UNITED STATES PATENT AND TRADEMARK OFFICE

APPLICATION NO.	FILING DATE	FIRST NAMED INVENTOR	ATTORNEY DOCKET NO.	CONFIRMATION NO.
10/600,195	06/20/2003	Kenneth R. Levey	13842	7477
7590 01/21/2005			EXAMINER	
PAUL F. DONOVAN			MITCHELL, KATHERINE W	
ILLINOIS TOOL WORKS INC. 3600 WEST LAKE AVENUE GLENVEIW, IL 60025			ART UNIT	PAPER NUMBER
			3677	
			DATE MAILED: 01/21/2005

DETAILED ACTION

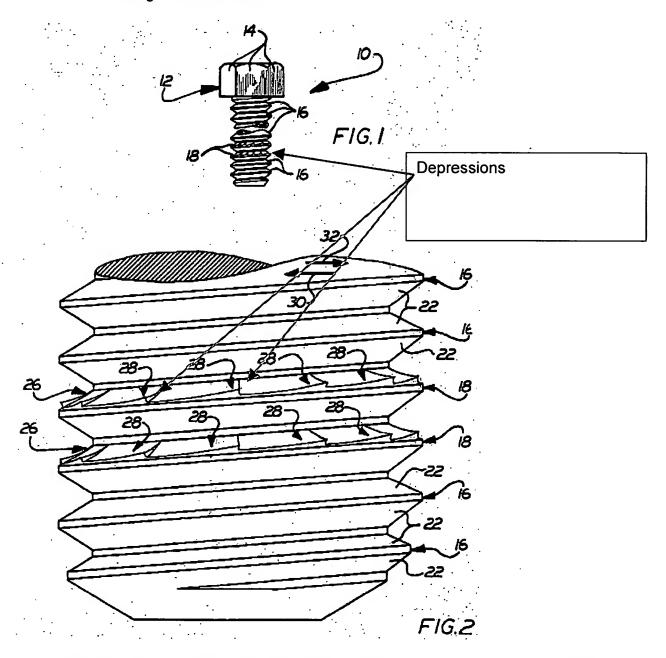
A series of depressions formed in said pressure flank. (see marked up Fig
 2 below) along at least a portion of a length of said thread

Re claims 4 and 9: Fig 2 shows the depressions extending inwardly along said pressure flank from said outer edge only part of a width of said pressure flank between shank and thread outer edge.

a series of depressions (best seen in Fig 2) formed in said pressure
 (facing head) flank (see marked up Fig 2 below) along at least a portion of
 a length of said thread.

Re claims 6 and 8: Fig 2 shows the depressions extending from shank to outer thread edge.
